Response to Request for Additional Information

PVNGS ITS 3.5.1 SAFETY INJECTION TANKS (SITs) - OPERATING

**ITS Section 3.5,
"Emergency Core Cooling Systems (ECCS)"**

Palo Verde Nuclear Generating Station

Figure 3.5.5-1
Minimum Required RWT Volume

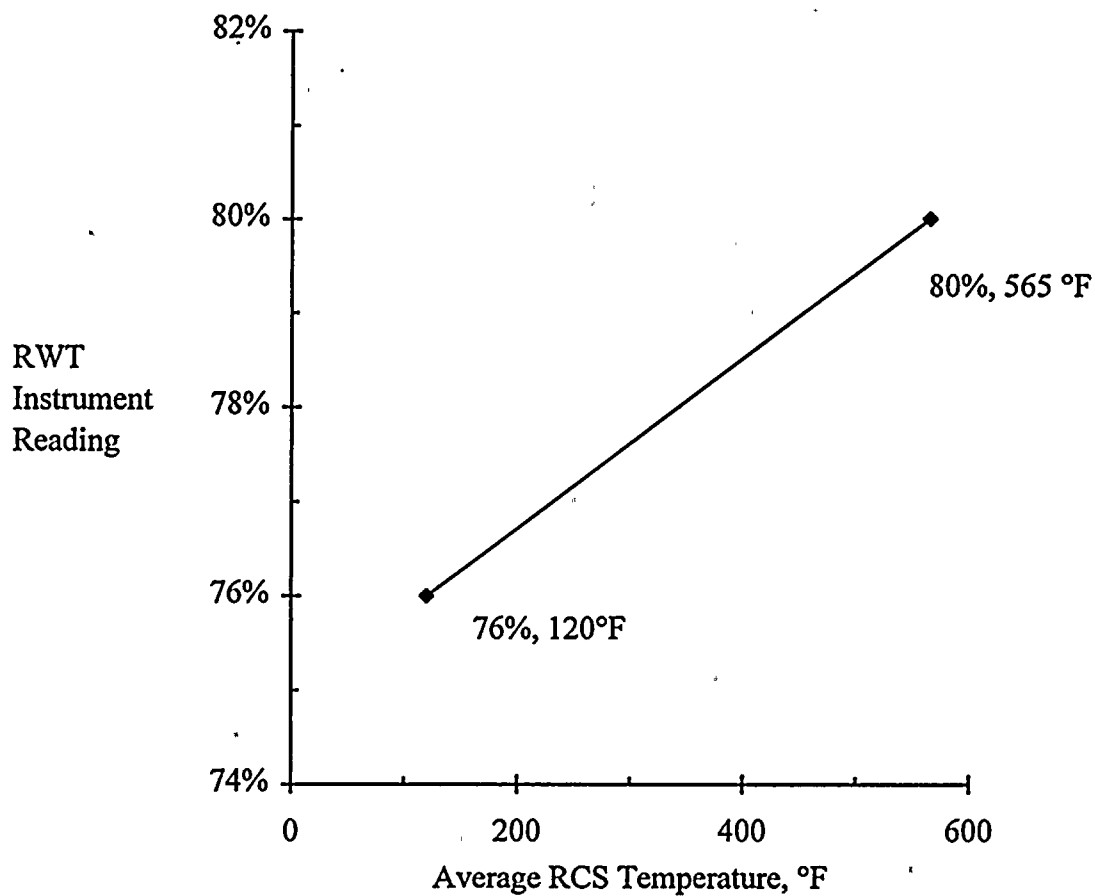
3.5.5-2	None	ITS Figure 3.5.5-1	<p>1) The LCO is only applicable in Modes 1-4 so why does the figure go down to 120 degrees F? Should the applicability include Mode 5? 2) Given that Figure 3.4.1-1 would allow Tc to go up to 570 degrees F, Tave could exceed the 565 degrees F of this Figure for a significant portion of Mode 1. Why does Figure 3.5.5-1 stop at 565 degrees F and what happens to required RWT level above that temperature (CTS Figure 3.1-1 would seem to indicate it continues to increase)?</p>	Potential changes to ITS Figure 3.5.5-1 (CTS Figure 3.1-1) are being evaluated. A response to this issue (3.5.5-2) will be provided in a future submittal.

FIGURE 3.1 + 3.5.5-1
MINIMUM BORATED WATER VOLUME
REQUIRED RWT

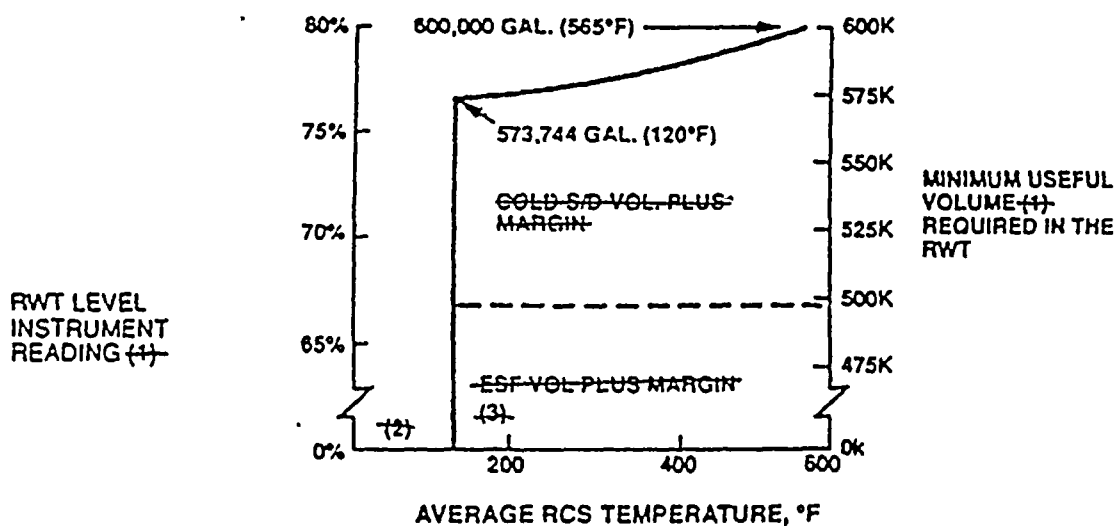
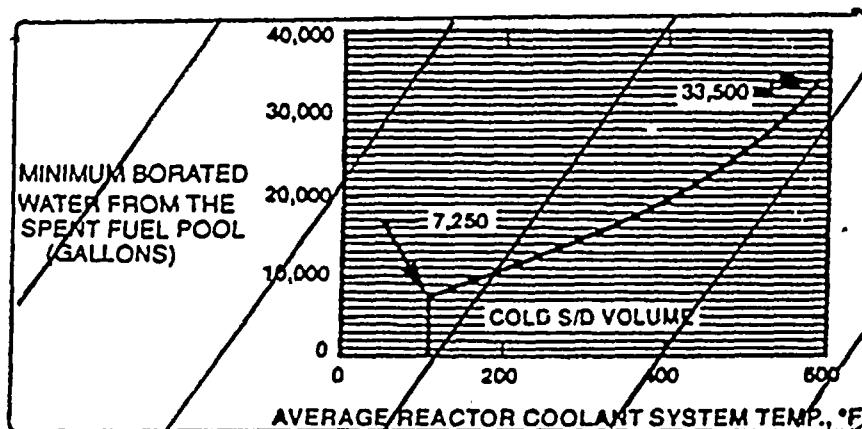
ISSUE #	DOC # or JFD #	CTS/STS REF	DESCRIPTION OF ISSUE	PVNGS RESPONSES
3.5.5-1	A.2	CTS Figure 3.1-1	<p>CTS Figure 3.1-1 includes the RWT and Spent Fuel Pool water volumes. ITS Figure 3.5.5-1 only retains the RWT water volume. The Spent Fuel Pool water volume has been moved to plant controlled documents. There is no discussion on which plant controlled document the CTS requirement was moved to or how it is controlled.</p> <p>Comments: Provide discussion on where the CTS requirement was moved and how it is controlled.</p>	The graph in CTS Figure 3.1-1 showing the minimum borated water volume in the spent fuel pool is being relocated to the Technical Requirements Manual (TRM), as described in the relocation matrix submitted to the NRC in letter 102-03942-JML/AKK/TNW/BM dated May 30, 1997. This relocation is addressed in the Split Report for CTS 3.1.2.6. The TRM will be controlled in accordance with the provisions of 10 CFR 50.59.

- A.2 CTS Figure 3.1-1, Minimum Borated Water Volume, includes both the RWT and spent fuel pool water volumes. CTS Figure 3.1-1 is moved to ITS 3.5.5, Figure 3.5.5-1. Since ITS 3.5.5 only addresses RWT volume, only the RWT volume figure is retained. Since SR 3.5.5.2 only addresses the minimum borated water volume, the design and analysis details in the figure are deleted. CTS 3.1.2.6 uses the spent fuel pool volume figure in CTS Figure 3.1-1. CTS 3.1.2.6 is relocated to the Technical Requirements Manual, as described in the Split Report.
